**ETS 300 347-1**  
pr **A1**

**This draft amendment A1, if approved, will modify  
the European Telecommunication Standard ETS 300 347-1 (1994)**

**Signalling Protocols and Switching (SPS);  
V interfaces at the digital Local Exchange (LE);  
V5.2 interface for support of Access Network (AN);  
Part 1: V5.2 interface specification**

Page 247, figure L.36.5, bottom left branch

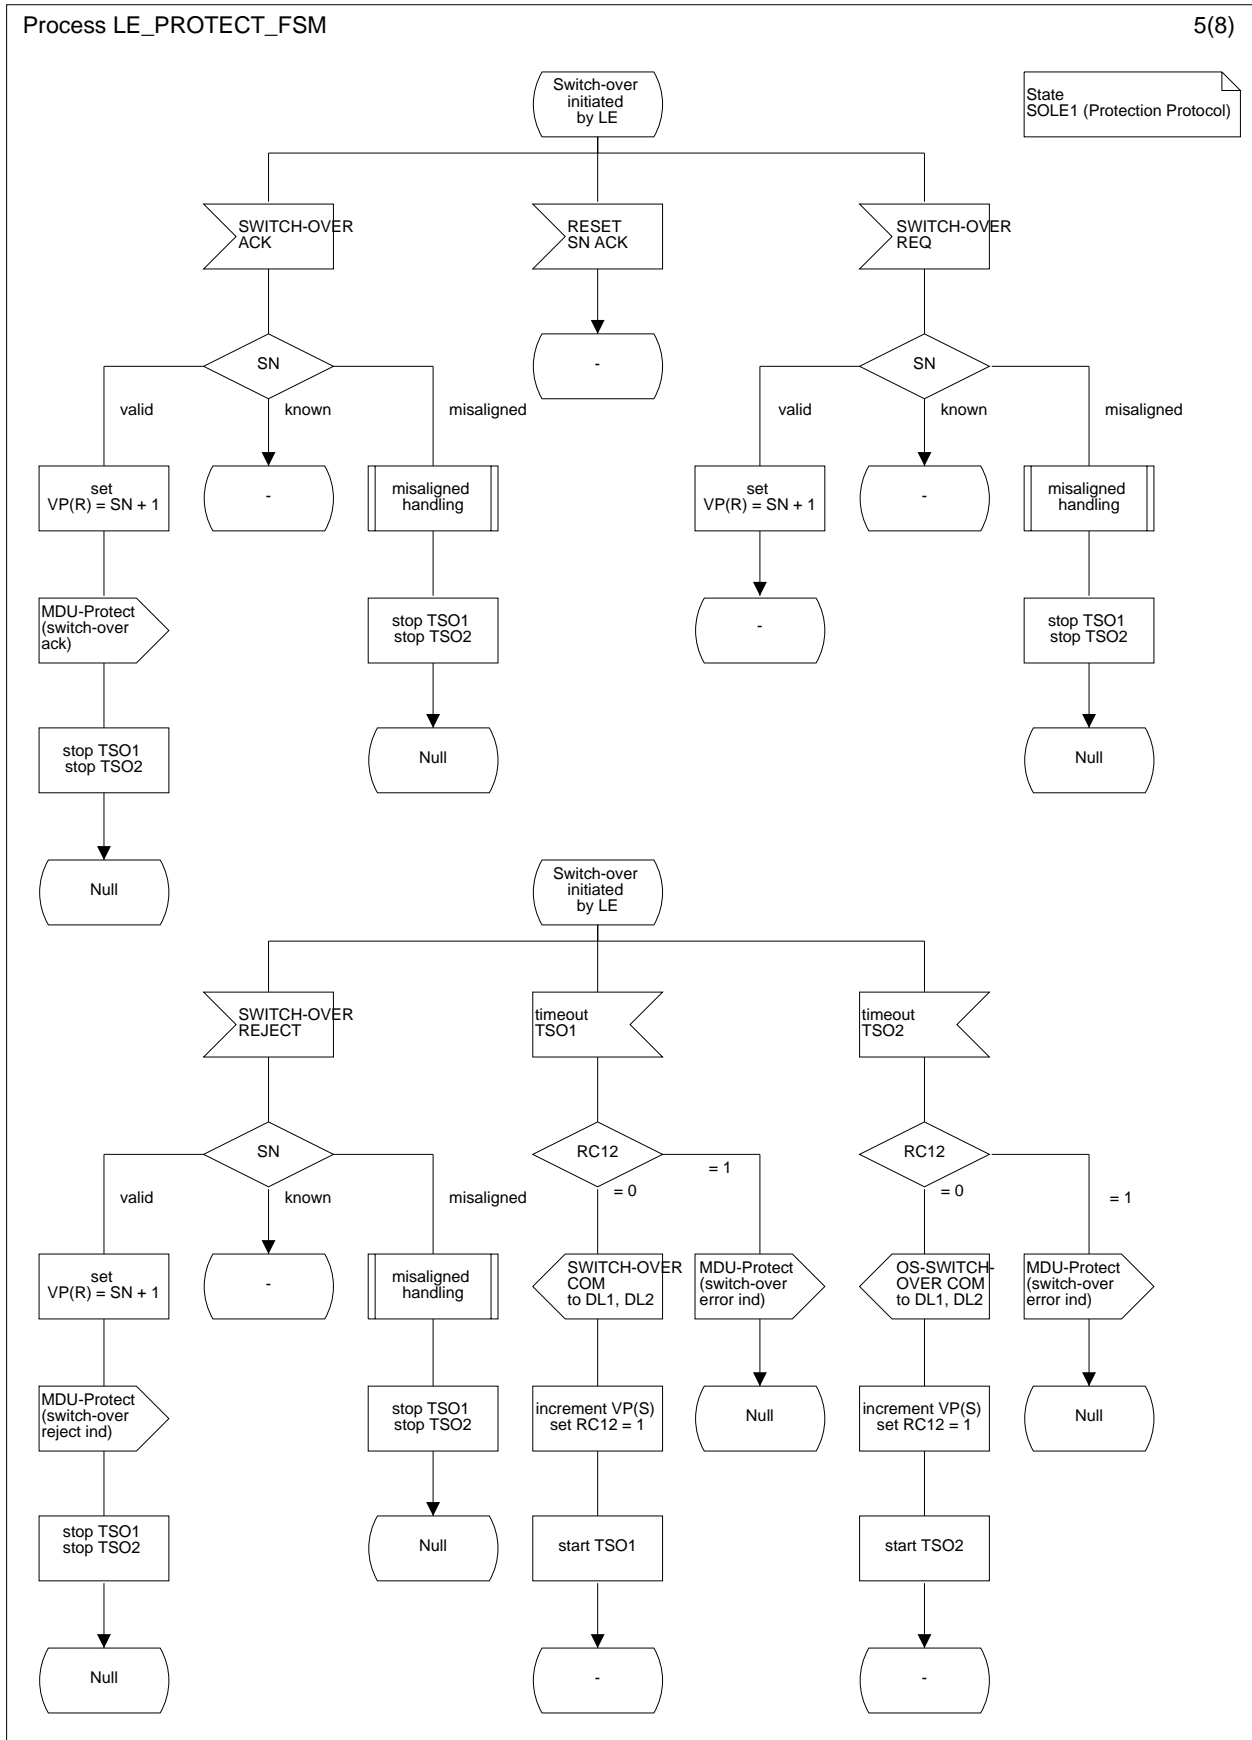
- Amendment: Both figures L.13.4 and L.36.4 are corrected with a task symbol to initialize VP(S) and V(P) before start of TSO4.
- Annex L, figure L.36.5: A stop of timer TSO2 is missing in the bottom left branch.

Insert "stop TSO2" into the task symbol "stop TSO1".

Page 249, figure L.36.7

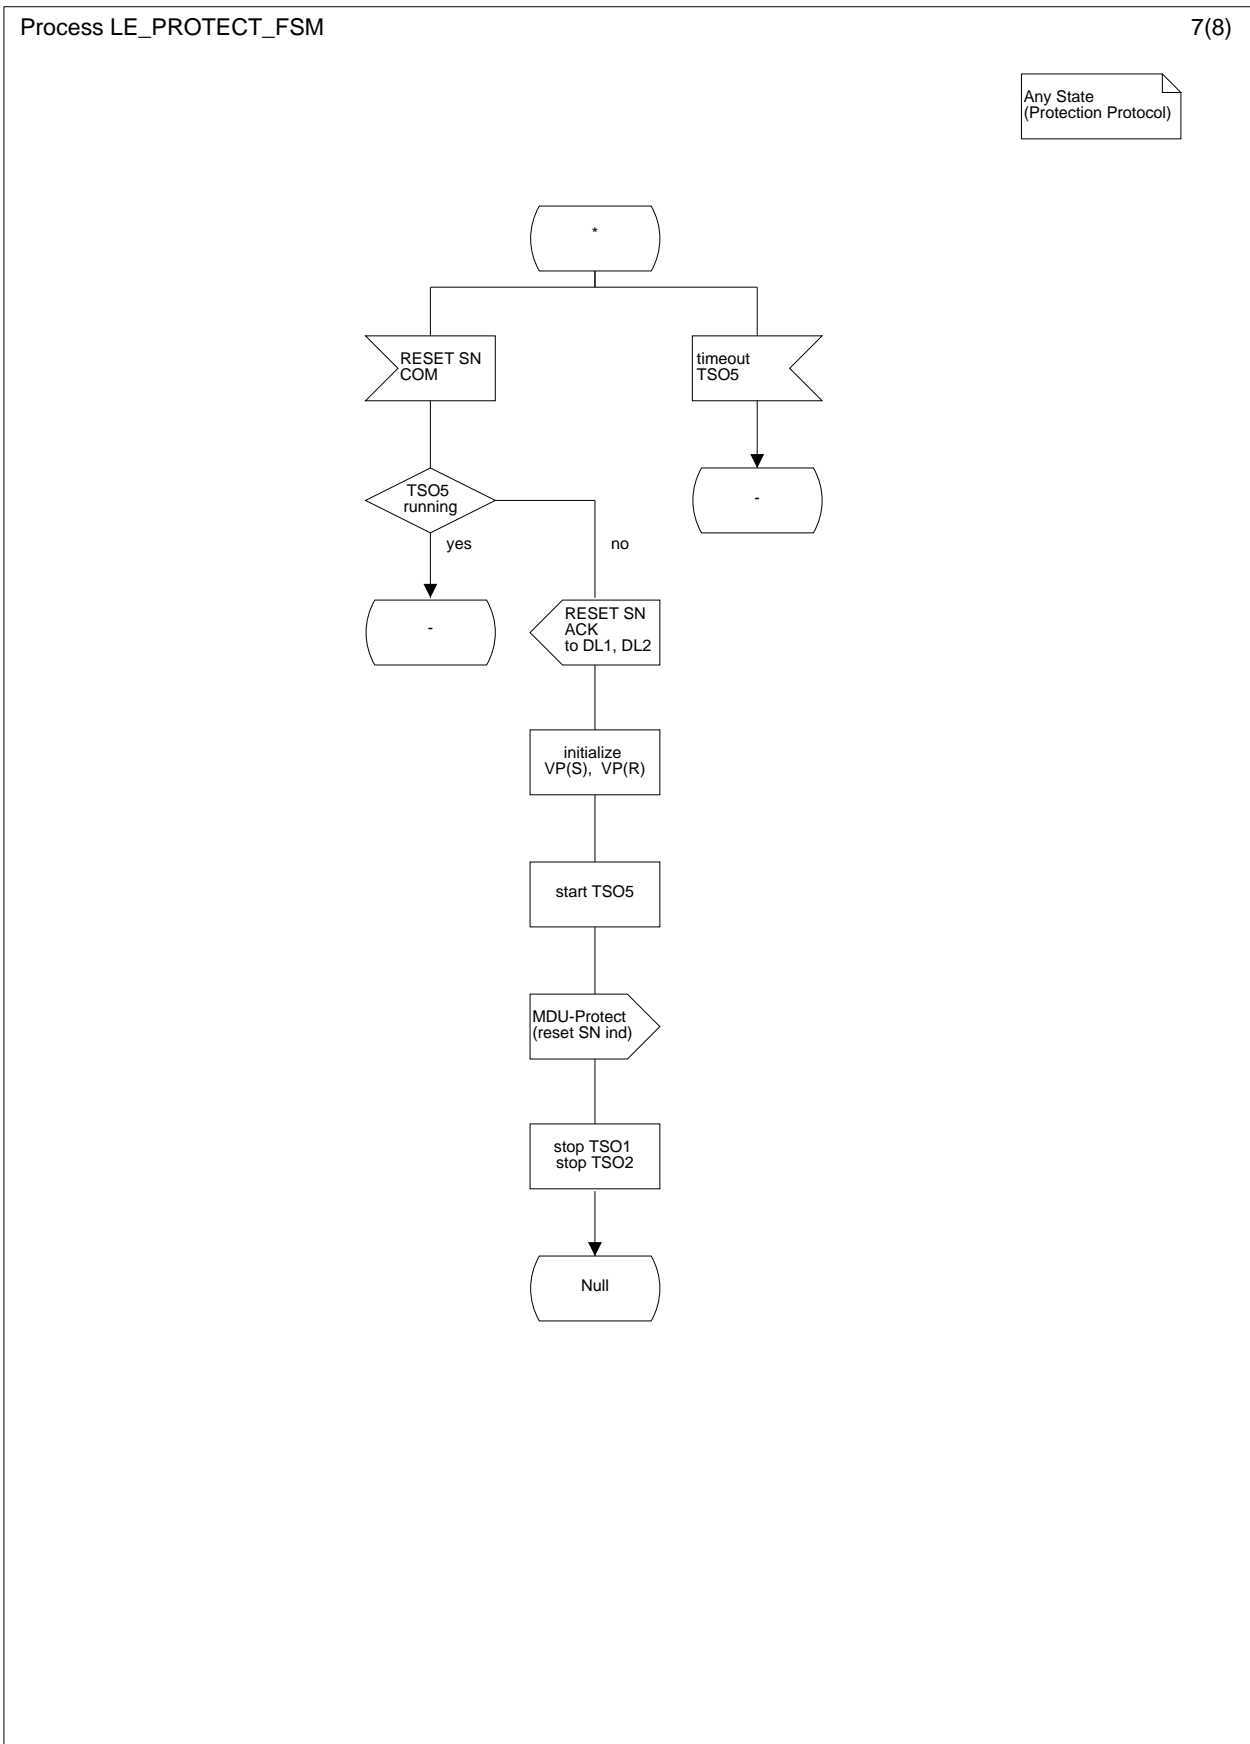
- Annex L, figure L.36.7: In the bottom diagram, the symbol for the message RESET SN ACK has the wrong direction.
- Annex M, table M.1: The following code points missing: RESET SN COM, RESET SN ACK and PROTOCOL ERROR. Table M.1 is inconsistent with table 51.

Flip the input symbol "RESET SN ACK".

**"L.2.8.7 Accelerated port alignment procedure**

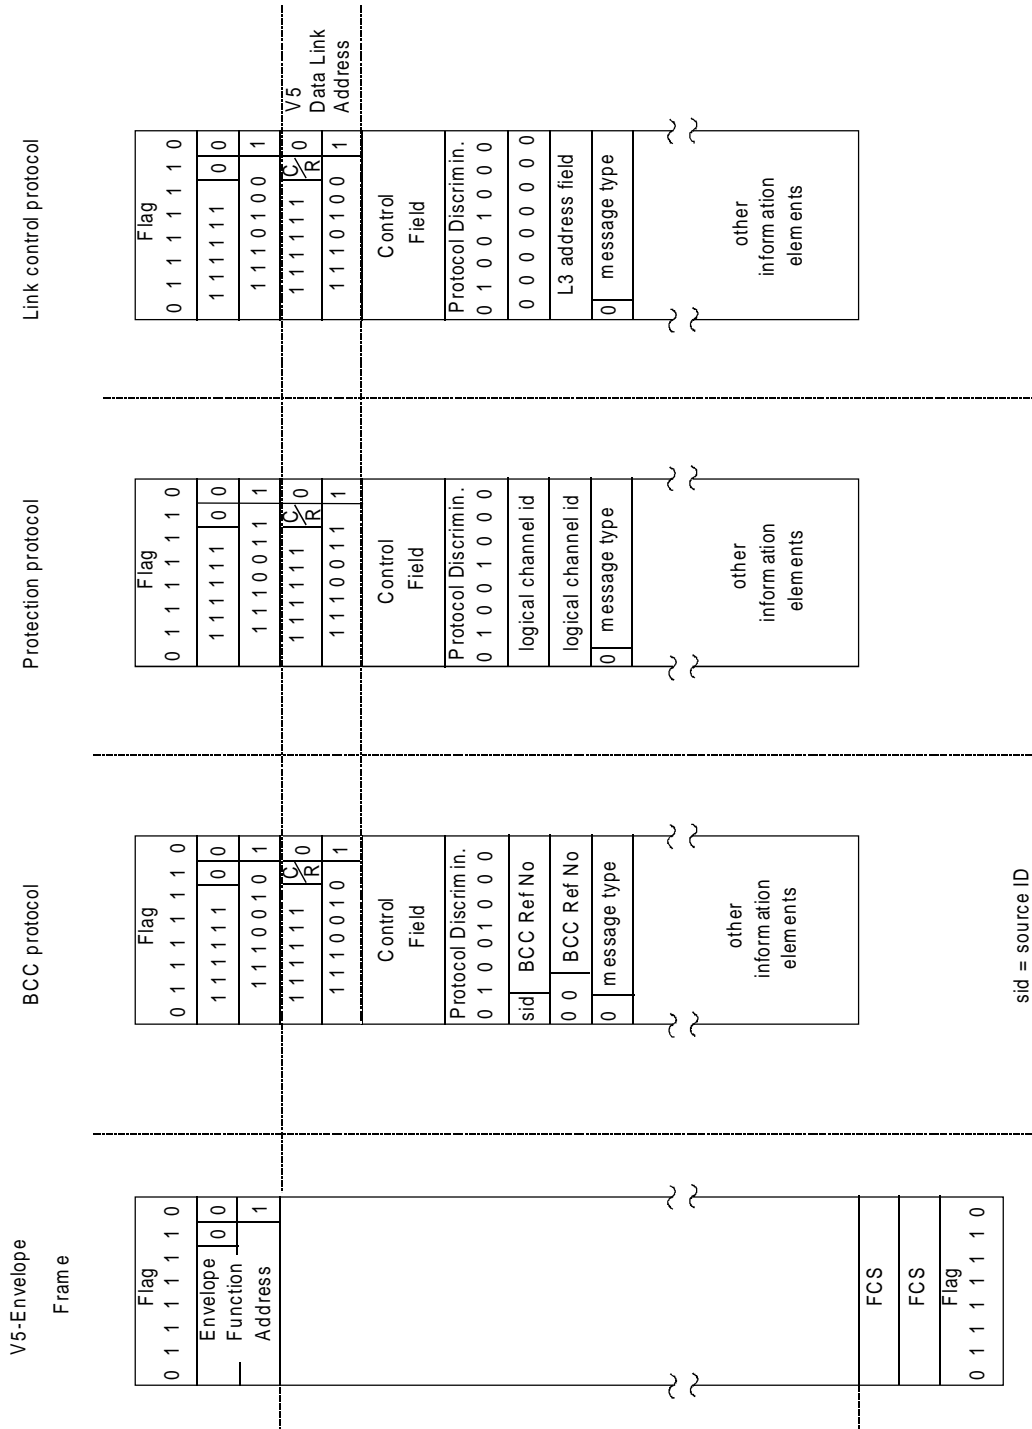
Insert a new subclause L.2.8.7 after figure L.37.4:
